1. No.	4. Present Name(s) Residence, John Pevear
2. County Summit	5. Other Name(s)
3. Location of Negatives HHA 33-30

6. Specific Location 81 Streetsboro Street	16. Thematic Category D	28. No. of Stories 1 1/2
	17. Date(s) or Period 1918	29. Basement? Yes <input checked="" type="checkbox"/> No <input type="checkbox"/>

81 E. Streetsboro St., Hudson, OH 44236

1. remove the four metal awnings from west side of house.

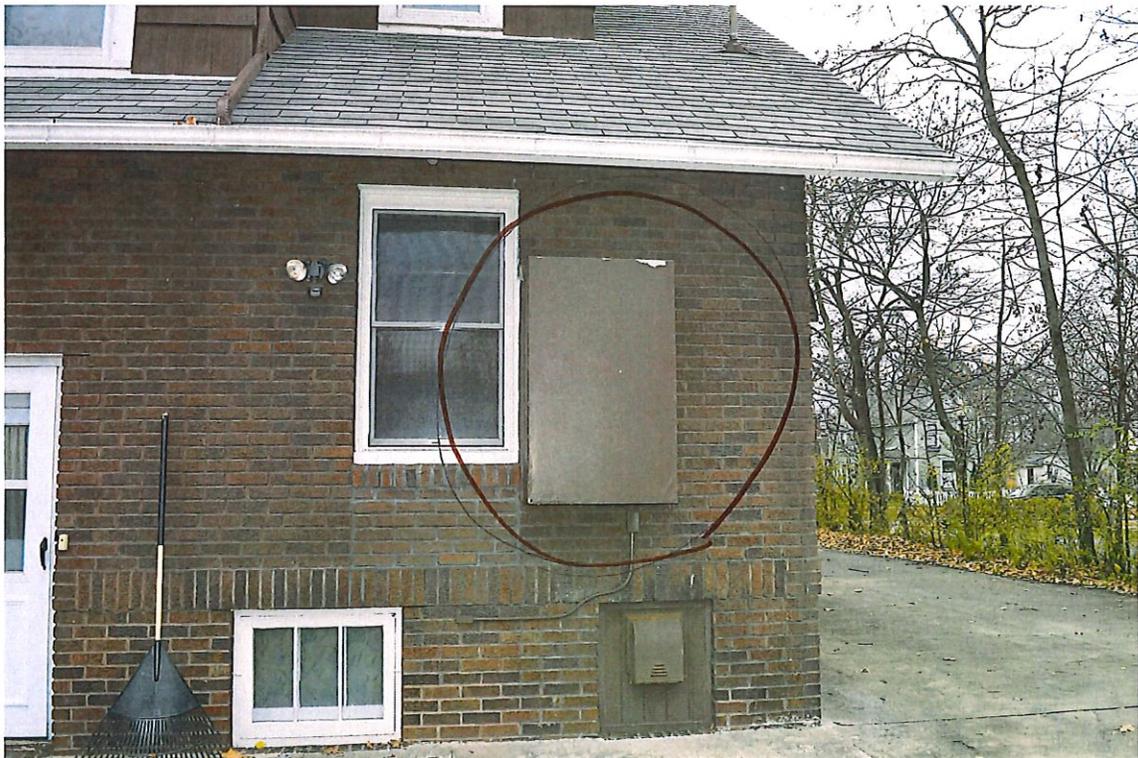
① remove the four metal awnings that are on the west side of house (these are the only awnings on the house)

2. remove oven box from rear exterior wall of house.

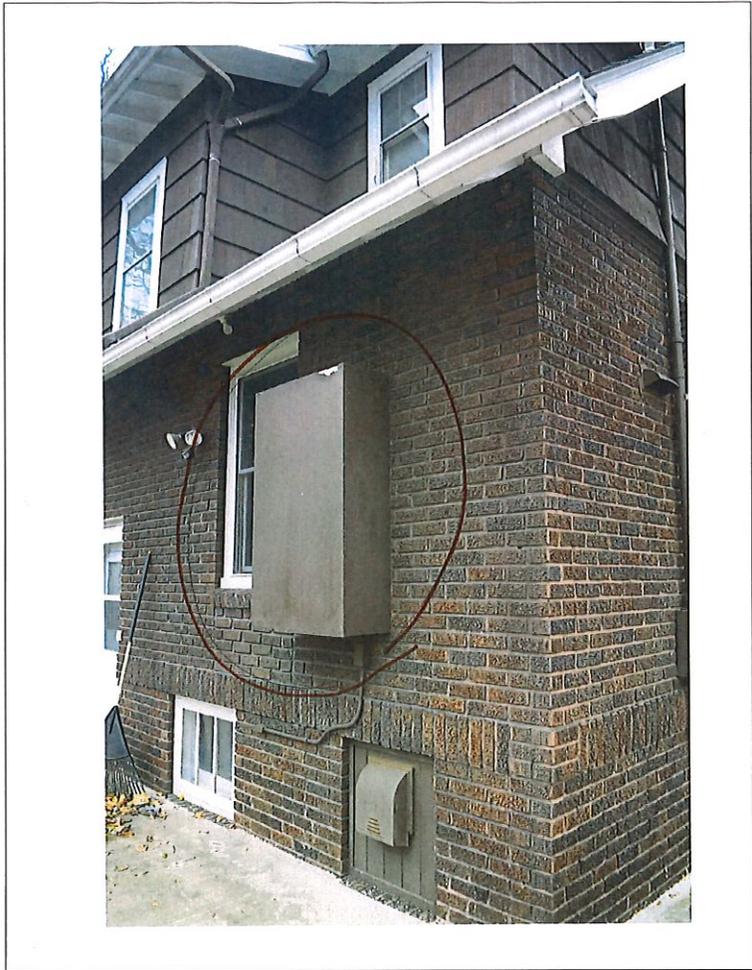
In the 70's a double wall oven was added flush to the exterior wall of the house. They then built a box protruding from the house to accommodate the oven.

We want to remove the box and patch the wall with brick to
match as close as
possible

② remove oven box the protrudes the exterior wall of house.
Re-brick in hole

4. Reorient the screen porch steps

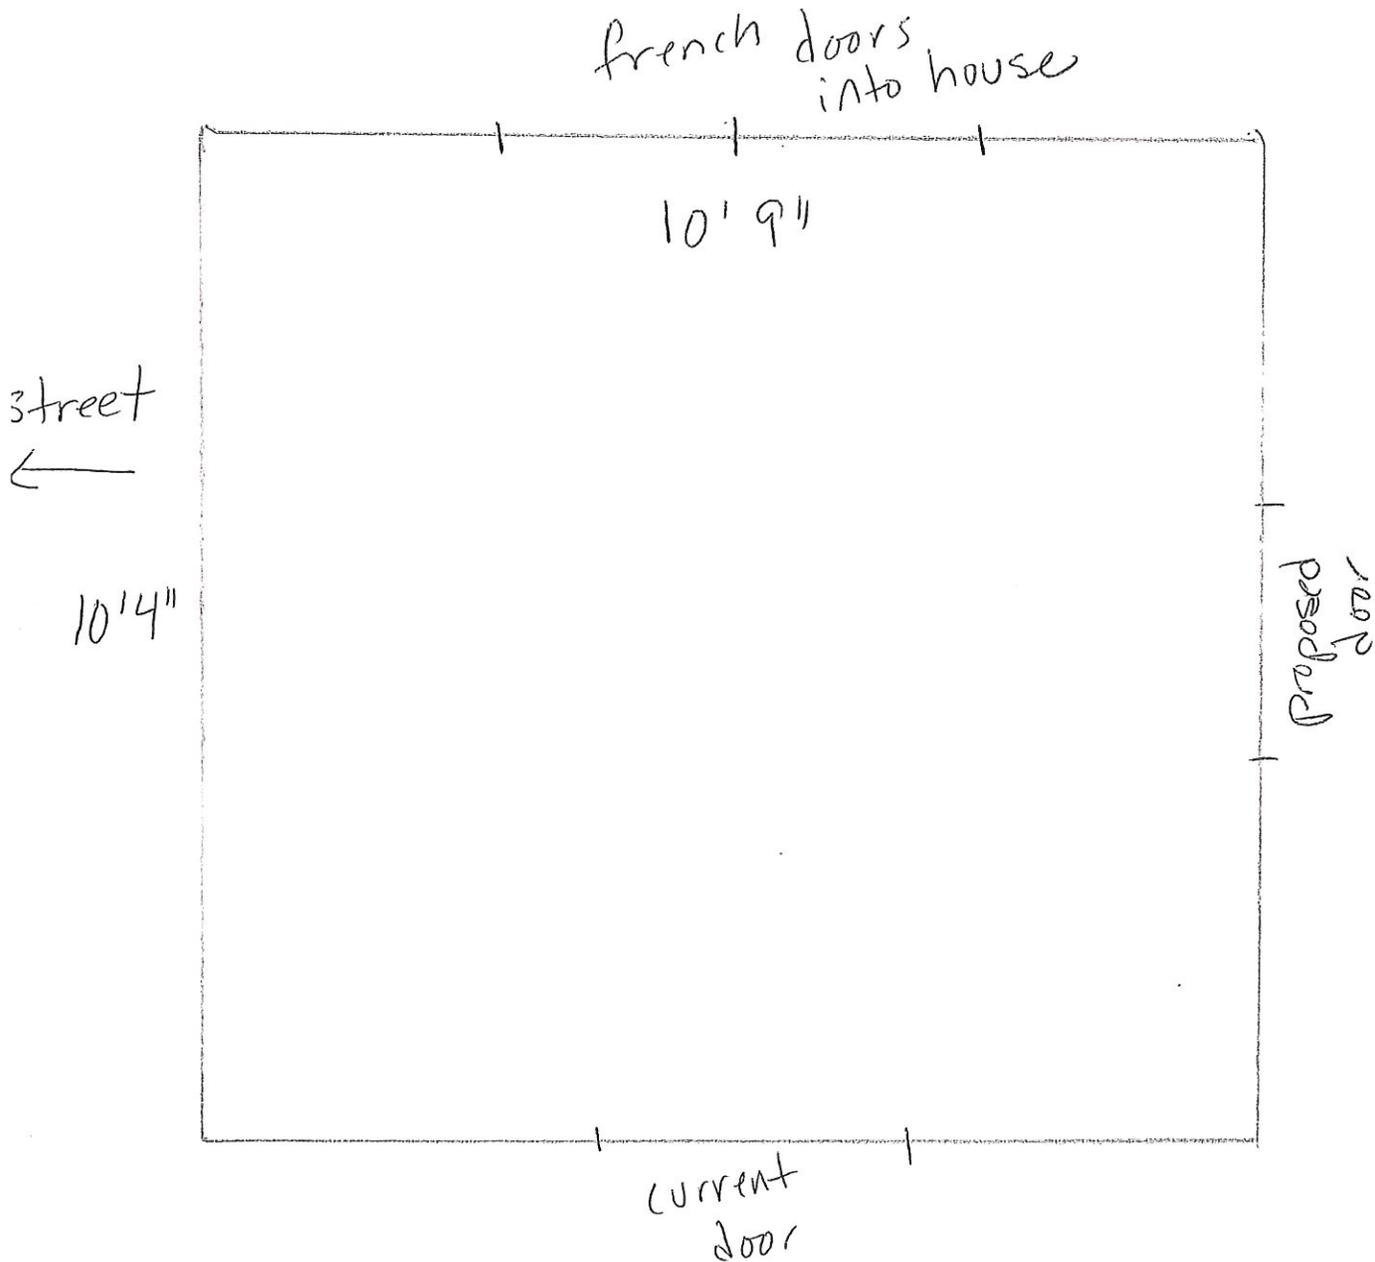
We would like to move the steps to the screen porch from the east side of the porch to the rear side of the porch. We would remove the current door and rescreen opening. The 15" span at the bottom of the door would be re-bricked in to look like one continuous wall. The new door off the rear of the porch would be 36" wide going to wood steps that are 48" wide. There would be four steps and wood posts and railings, painted white to match the other wood trim. A sample photo of intended style of steps is enclosed.

reorient screen porch steps from east side of porch to
the rear side of porch
(steps + door)

door - 36" wide
steps - 48" wide

plan for new steps (wood w/ wood railings+posts) 48" wide

MAP OF SURVEY

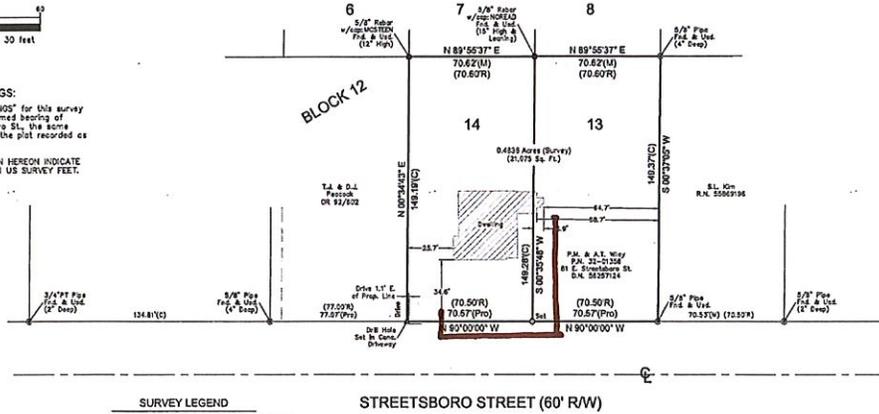
There is a 5' tall hedge along the front of the house along the sidewalk. There are several large spans of the hedge that are dead, so we would like to remove it and replace it with a picket fence. The fence would run from the east edge of the driveway, across the front of the house for 60' and then turn the corner down the east side of the lot for 60' to the edge of the porch. There would be one 8' return panel along the driveway. The fence would have 6" x 6" posts that are 3 ½' high and 8' spans of picket that are 3' high. A sample photo of 198 Aurora street is enclosed to show style of fence. Also enclosed are copy of survey and lot map with fence line drawn in.

remove hedge and replace with wood (painted white) picket fence 3' high
(see lot map)
